CITY OF NAPOLEON - BUILDING DEPARTMENT
255 West Riverview Avenue, Napoleon, Ohio 43545 - 419-592-4010

Job Location 910 Harmony
address

RESIDENTIAL PLAN CORRECTION SHEET

ADDENDUM TO Permit No. 01659-(1)
Owner DON DEHNHOLZ
Contractor BECK'S CONSTRUCTION
Location 910 HARMONY

SITE PLAN FOR
BECKS CONSTRUCTION CO.
 LOT NO. 29, PHASE I BRICKYARD SUB-
 DIVISION, CITY OF NAPOLEON, HENRY CO., OHIO.

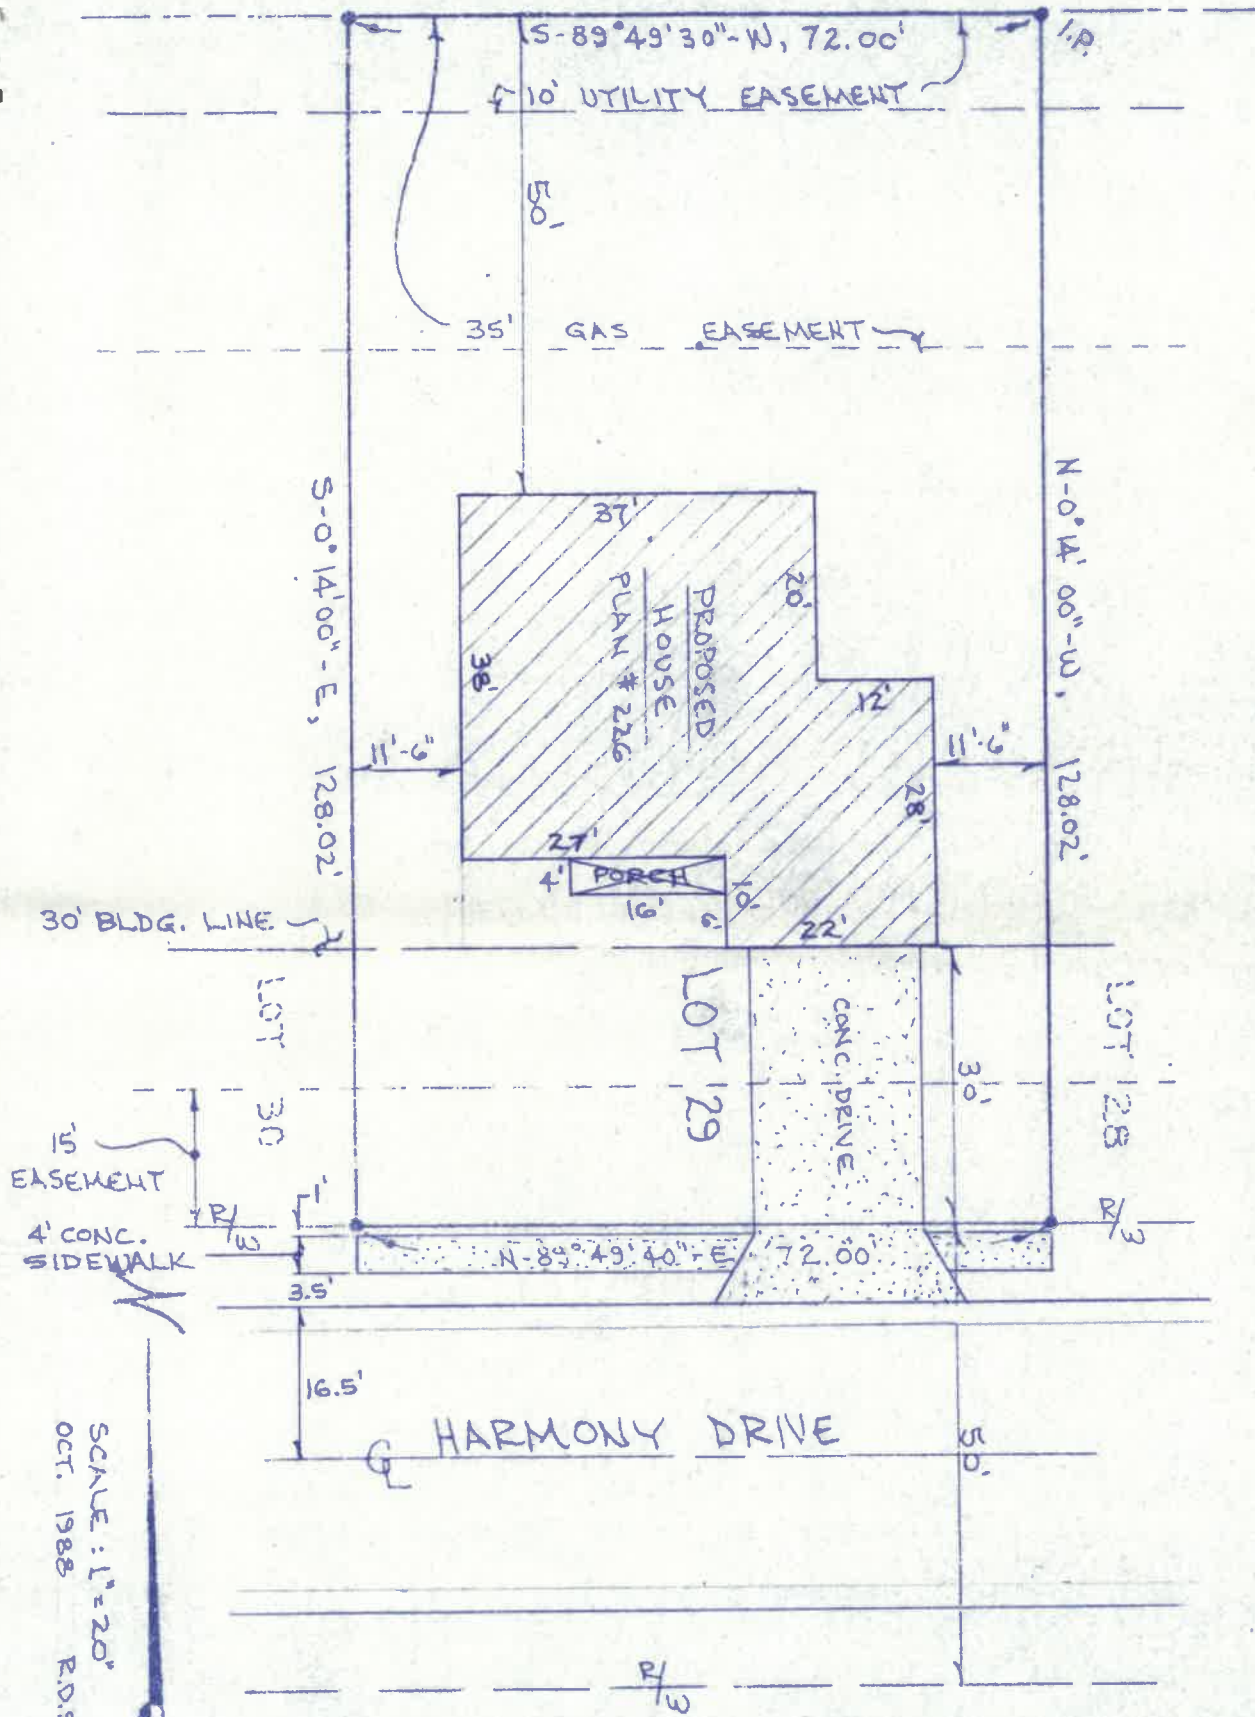
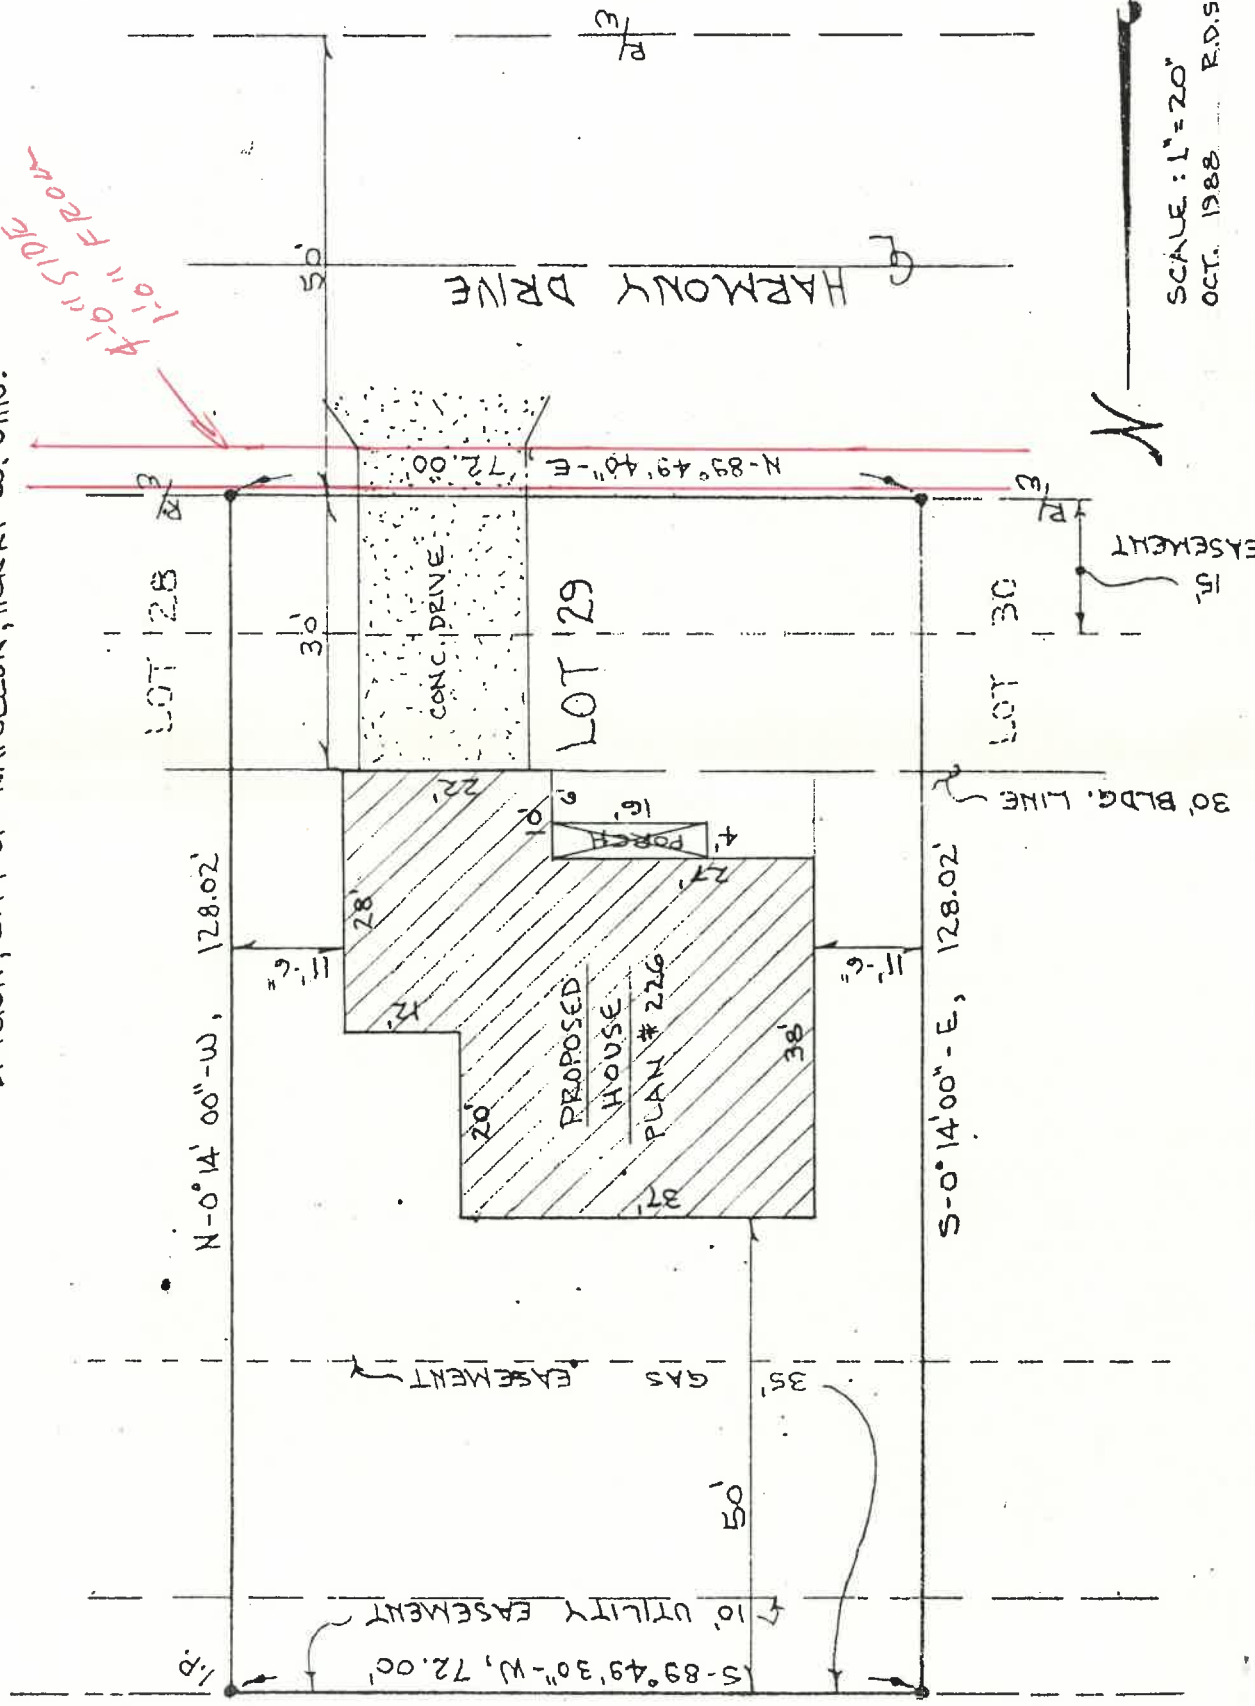
INSTALL SIDEWALKS AS SHOWN ON SITE PLAN
WALKS TO BE LOCATED 1.0' FROM THE HARMONY
R.O.W. LINE AND BE 4.0' WIDE. CONTACT THE
NAROLON CITY ENGINEERING DEPT. FOR LINE & GIRDER
AND MIN. REQUIREMENTS.

IN THE SIDEWALKS AS SHOWN ON SITE PLANS
MARKS TO BE LOCATED 10' FROM THE HARMONY
R.O.W. LINE AND BE 4'0" WIDE. CONTACT THE
ARLINGTON CITY ENGINEERING DEPT FOR LINK + GRADE
AND MIN. CLEARANCE.

*4'-0" SIDE
 1'-0" FROM
 COALIC
 PROP. CL. 11/8*
